Access Compliance Report

Public Rights-of-Way

(Curb Ramps)

Intersection ID: 17324	Main Street: KENSAL_CT	Cross Street: PROVIDENCE_RD	Location: SE
ADA ID: DAAF99319D79	Ramp Type: Perp	Initial Pass/Fail: Fail	Overall Compliance: No
		Severity Score: 22.5	
Codes/Mitigation Info/Possible Solution		Field Measurements/Component Compliance

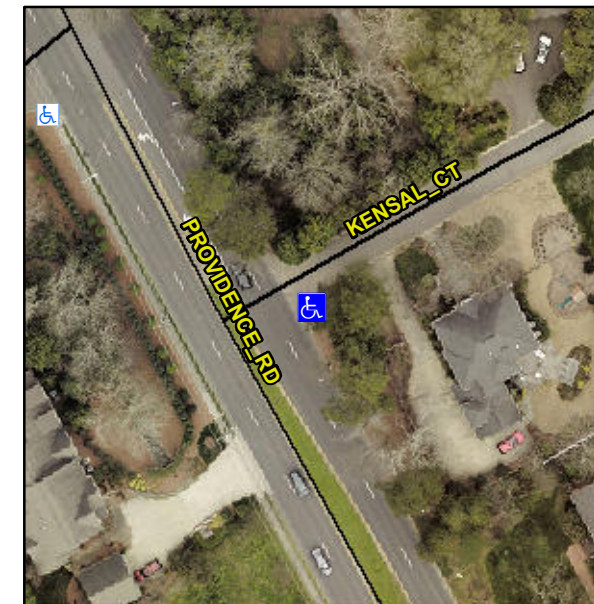
Not Found, R304.5.1, R304.2.2, R304.5.3

Compliance	Description	Data	Compliance	Description	Data
N/A	Ramp Length (in)	54.0	No	Ramp Slope (%)	8.9
No	Ramp Width (in)	44.0	No	Ramp XSlope (%)	2.4
N/A	Flare Type LT	N/A	N/A	Flare Type RT	N/A
N/A	Flare Slope LT (%)	N/A	N/A	Flare Slope RT (%)	N/A
N/A	Flare Traversable LT?	N/A	N/A	Flare Traversable RT?	N/A
N/A	Landing Length (in)	N/A	N/A	DWS Provided?	N/A
N/A	Landing Width (in)	N/A	N/A	DWS Contrast?	N/A
N/A	Landing Slope (%)	N/A	N/A	DWS Length (in)	N/A
N/A	Landing X Slope (%)	N/A	N/A	DWS Full Width?	N/A
N/A	Landing Curb? (Y/N)	N/A	N/A	DWS Offset (in)	N/A
N/A	Shared Landing?	N/A			
N/A	Gutter Ponding?	N/A	N/A	Gutter Slope (%)	N/A
N/A	Gutter Lip Ht (in)	N/A	N/A	Gutter X Slope (%)	N/A
N/A	Painted X Walk1?	No	N/A	Painted X Walk2?	N/A
	X Walk 1 Direction	To NW		X Walk 2 Direction	N/A
N/A	X Walk 1 Width (in)	N/A	N/A	X Walk 2 Width (in)	N/A
	X Walk 1 Slope (%)	1.8		X Walk 2 Slope (%)	N/A
	X Walk 1 X Slope (%)	1.8		X Walk 2 X Slope (%)	N/A

Remove & Replace Entire Ramp.
